4.0 ENVIRONMENTAL SURVEILLANCE

Justification for Proposed ETS Change 1

Justification for Proposed ETS Change 2

Figure 5.2-1

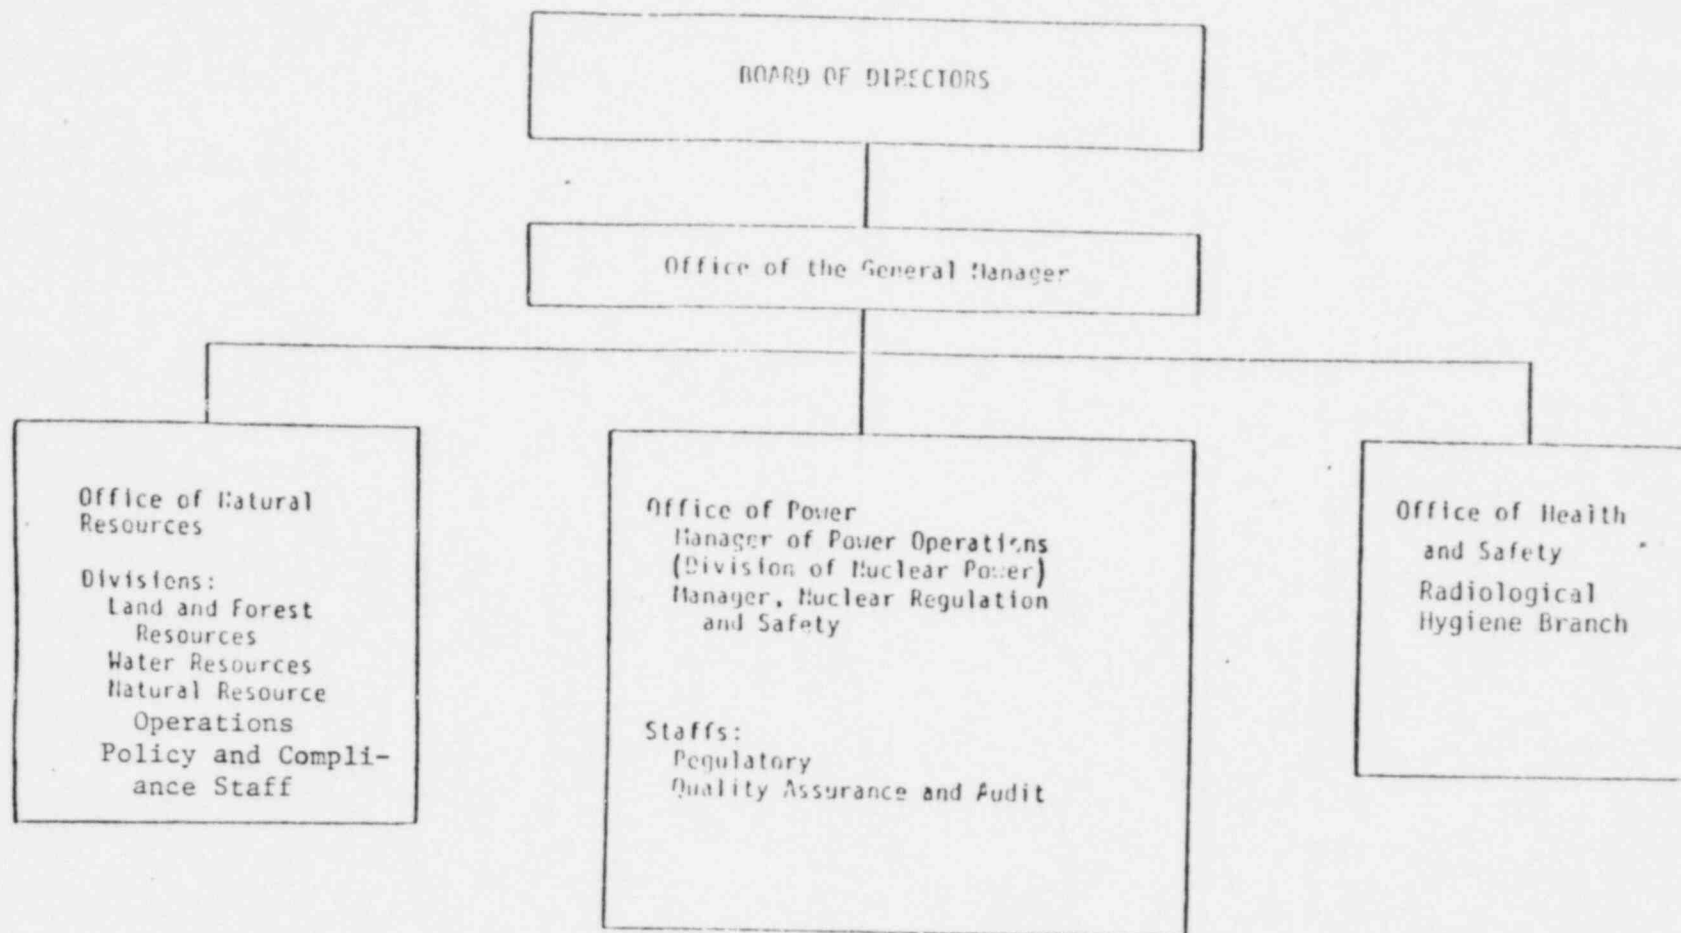
Changes to section 5.0, Administrative Controls, were made to reflect recent reorganizations and changes in the organizational responsibilities within TVA.

- 5.2.1 The organization of TVA management which directly relates to operation of the plant is shown on Figure 5.2-1.
- 5.2.2 The principal organizations within TVA which are concerned with environmental matters related to nuclear power plant operations are the Office of Power, Office of Natural Resources, and the Office of Health and Safety. The Office of Power is directly responsible for operating the plant in accordance with specified requirements and conducting onsite monitoring. The Office of Natural Resources and the Office of Health and Safety are responsible for providing technical guidance, assistance, monitoring, and other services as needed for environmental compliance. The organizations above report to the General Manager as shown in Figure 5.2.1.
